FIRE MARSHAL COMMENTS

DATE: 02-Aug-12
TO: Brian Donnelly
Macris, Hendricks & Glascock
FROM: Marie LaBaw
RE: Goddard School - Olney
720110040 120120150 820120110

RE: Preliminary Plan No. 120120150
Goddard School-Olney

SIGHT DISTANCE EVALUATION

PLAN SHOWING LOCATION OF MORNINGWOOD DRIVE/ALLEY INTERSECTION (DRIVEWAY # 2) AND PROPOSED CONDITION SIGHT LINE TO THE WEST NORTHWEST

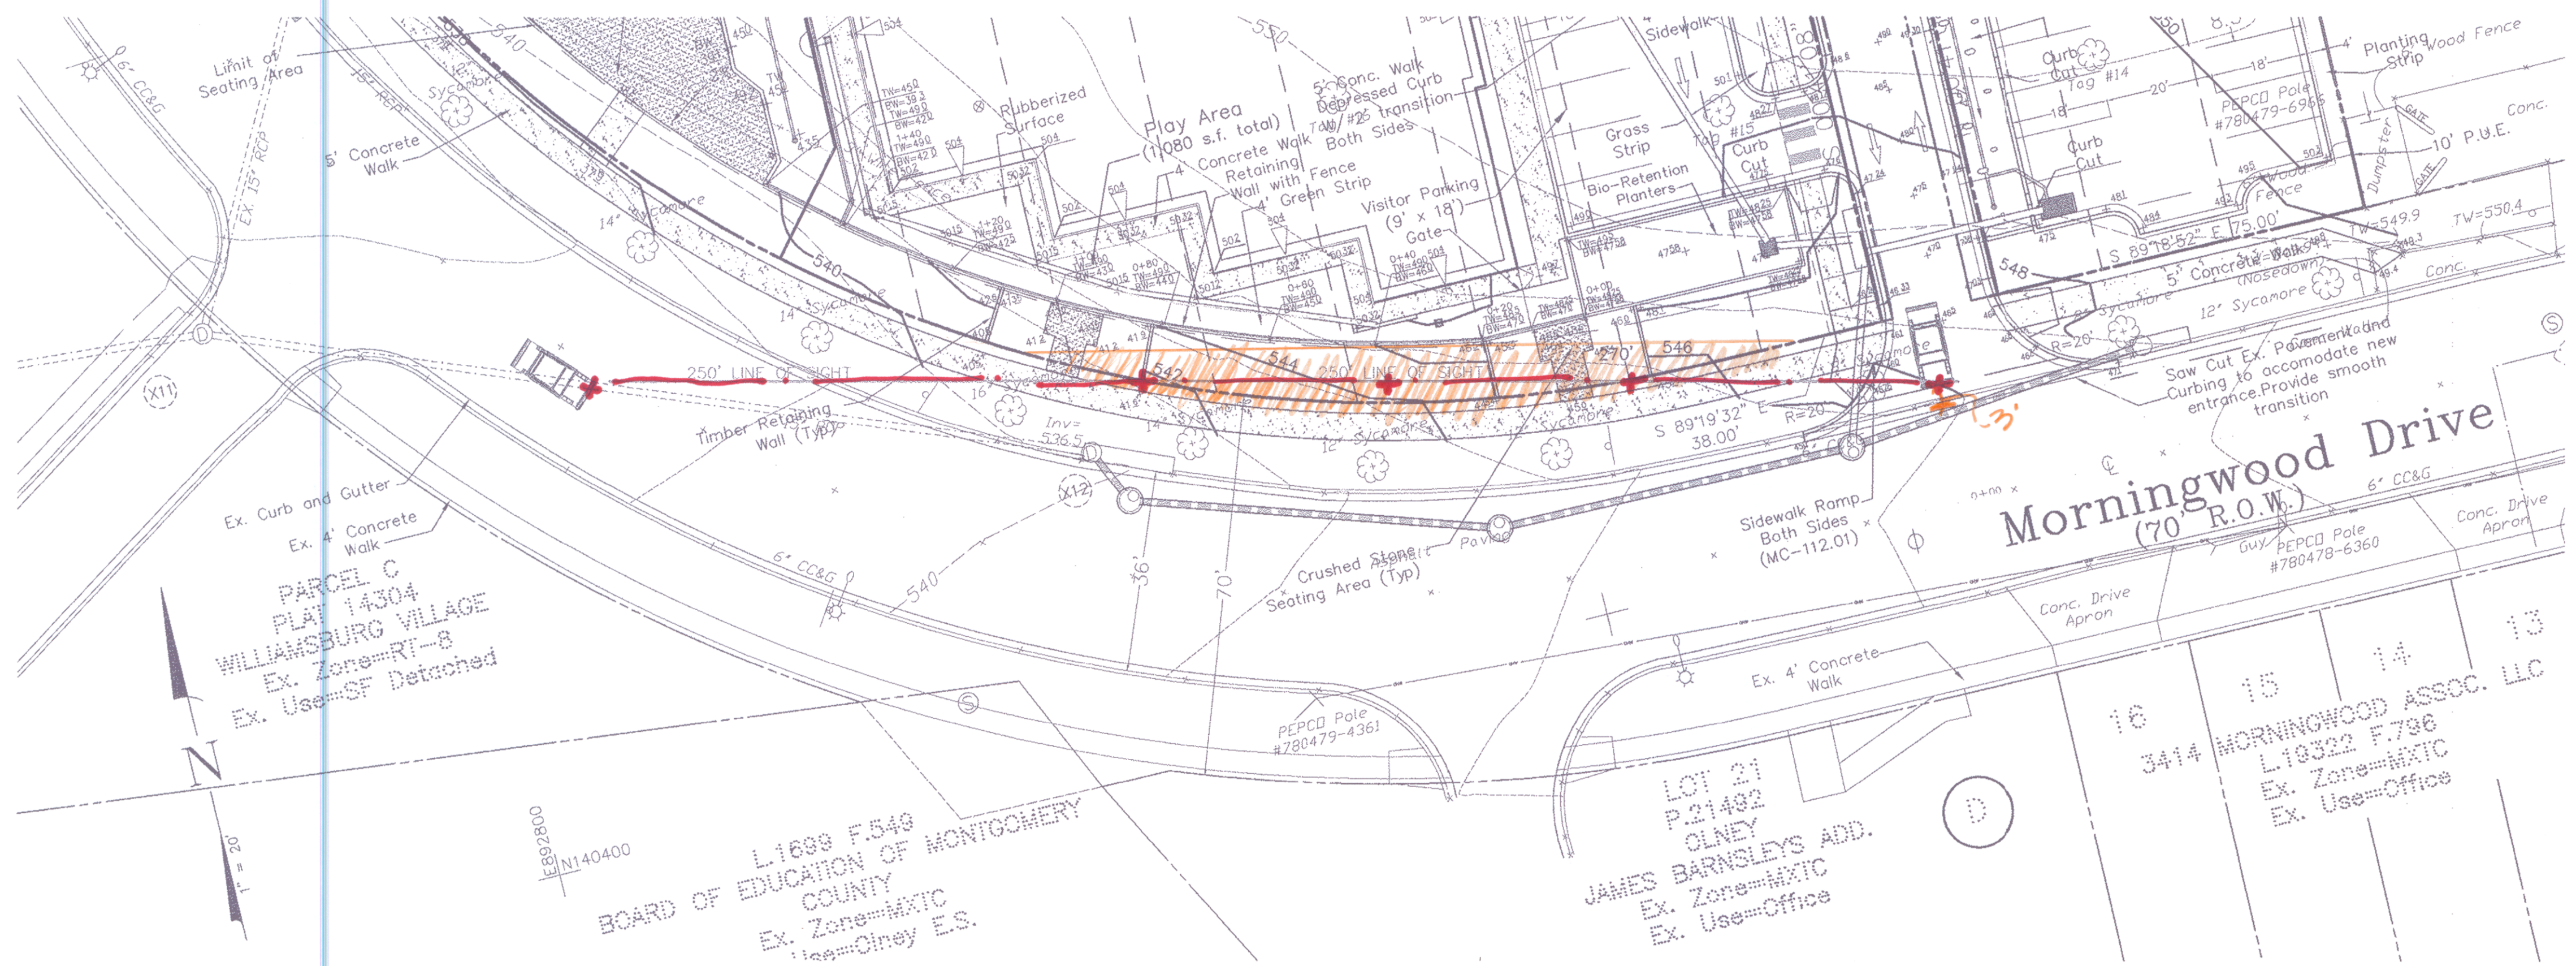
9. The sight distances study for visibility from the alley at Morningwood Drive has **NOT** been accepted. The applicant has prepared a sight distance exhibit which suggests the two hundred fifty (250) foot visibility requirement for a primary residential street is attainable upon completion of necessary clearing and final grading. However, the proposed line of sight crosses outside the public right-of-way (onto the private property) and may conflict with on-site improvements.

We recommend approval of this plan be approved conditioned on the applicant achieving the visibility requirement (to DPS' satisfaction) prior to the issuance of any building permits for this site. No physical objects (other than possible future underground utility installations within the Public Utilities Easement) should be allowed within the line of sight behind the property line. Within the public right-of-way, the proposed streetlight and street tree installations should be field located (and perhaps trees spaced at irregular distances) at the permit stage to optimize visibility at this intersection.
